ANALYSIS

ORDINANCE NO. 2013-0048

An ordinance amending Title 26 – Building Code of the Los Angeles County Code, by adopting the 2013 California Building Code, by reference, with certain changes and modifications, and making other revisions thereto.

FIGURE 1809.3

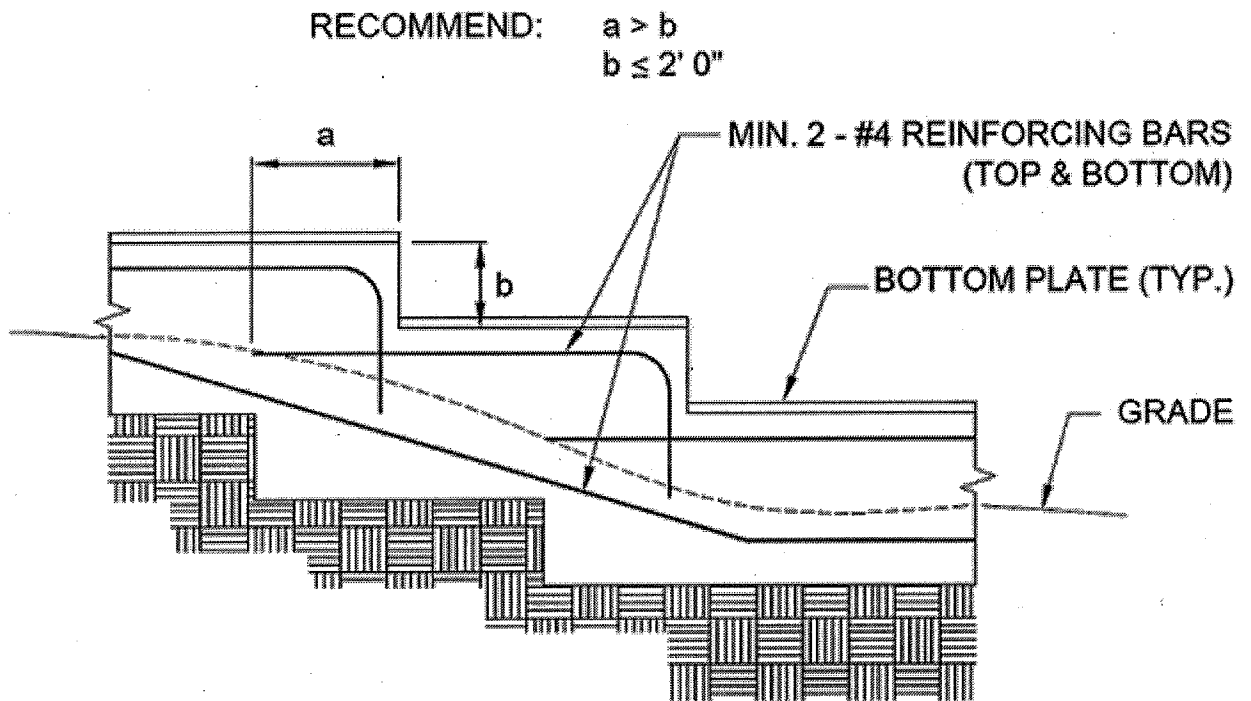
For structures assigned to Seismic Design Category D, E, or F, the stepping requirement shall also apply to the top surface of grade beams supporting walls.
Footings shall be reinforced with four 1/2-inch diameter (12.7 mm) deformed reinforcing bars. Two bars shall be placed at the top and bottom of the footings as shown in Figure 1809.3.

Figure 1809.3 is hereby added to read as follows:

FIGURE 2308.9.3.2
ALTERNATE BRACED WALL PANEL ADJACENT TO A DOOR OR WINDOW OPENING

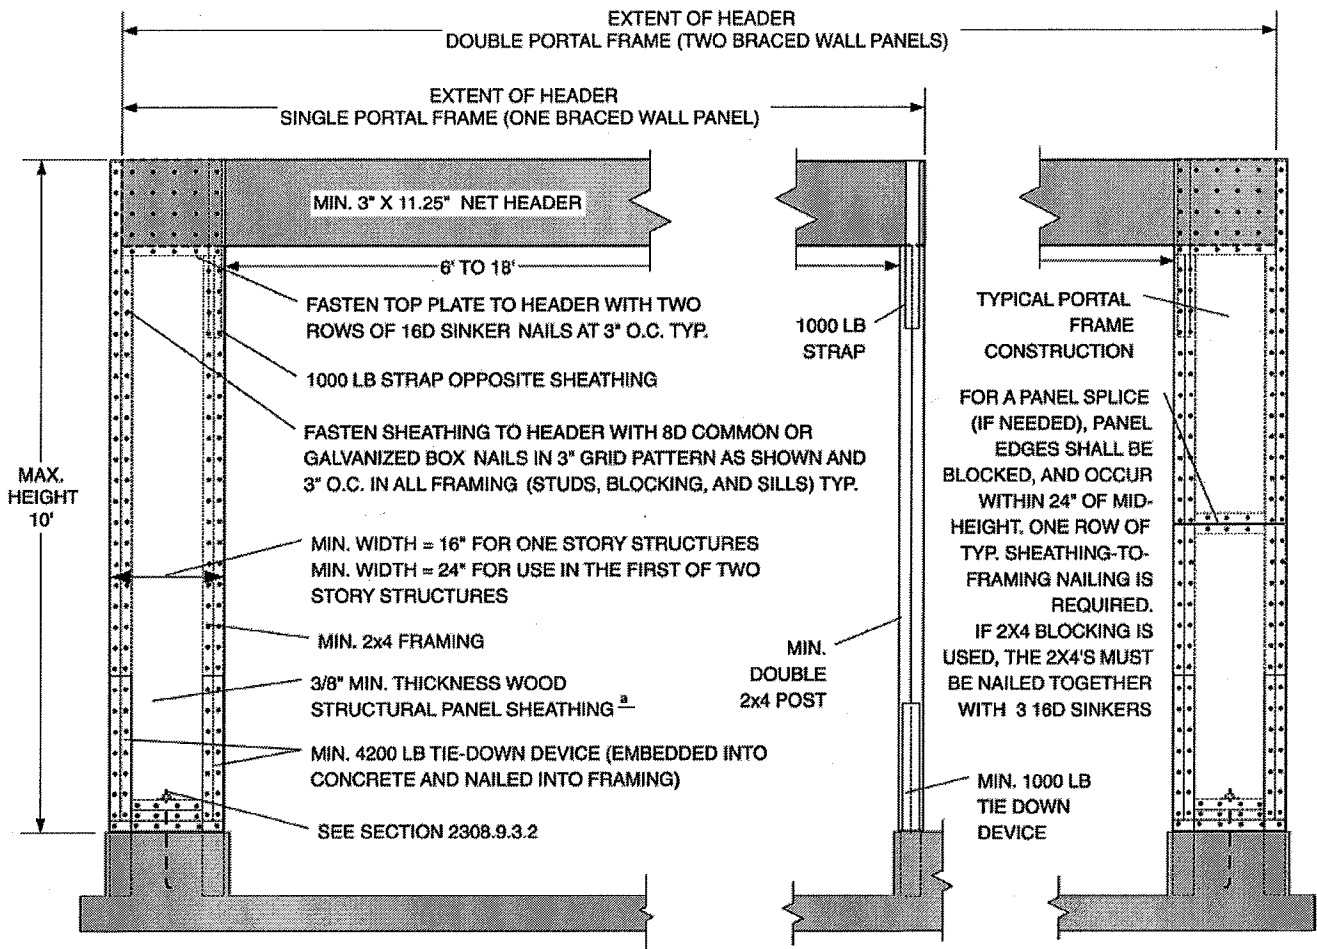
SECTION 55. Figure 2308.9.3.2 is hereby amended to read as follows:

FIGURE J108.1
DRAINAGE SETBACK DIMENSIONS

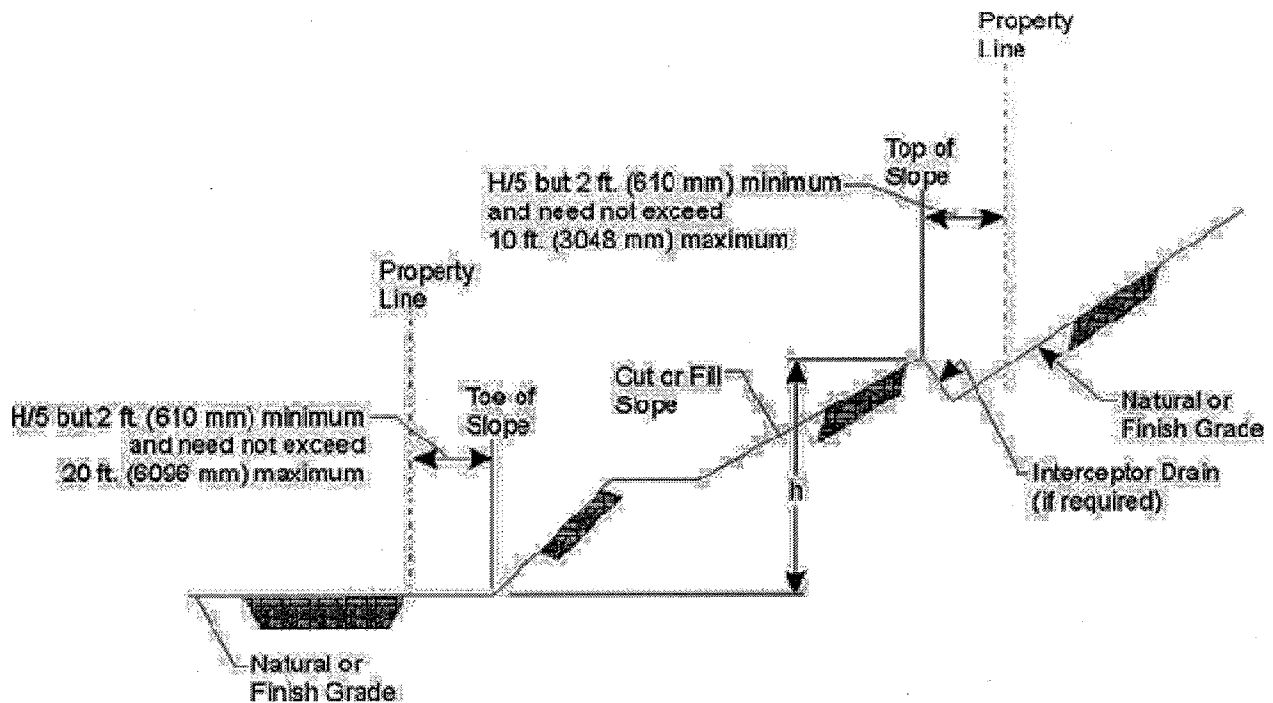
Cut and fill slopes shall be set back from the property lines in accordance with this sSection. Setback dimensions shall be measured perpendicular to the property line and shall be as shown in Figure J108.1, unless substantiating data is submitted justifying reduced setbacks and reduced setbacks are recommended in a geotechnical engineering and engineering geology report approved by the Building Official.

The setback at the top of a cut slope shall not be less than that shown in Figure J108.1, or than is required to accommodate any required interceptor drains, whichever is greater. For graded slopes the property line between adjacent lots shall be at the

The setback from the toe of a fill slope shall not be less than that shown by figure J108.1. Where required to protect adjacent properties at the toe of a slope from adverse effects of the grading, additional protection, approved by the bBuilding eOfficial, shall be included. Such protection may include but shall not be limited to:

SECTION 99. Figure J108.1 is hereby amended to read as follows:
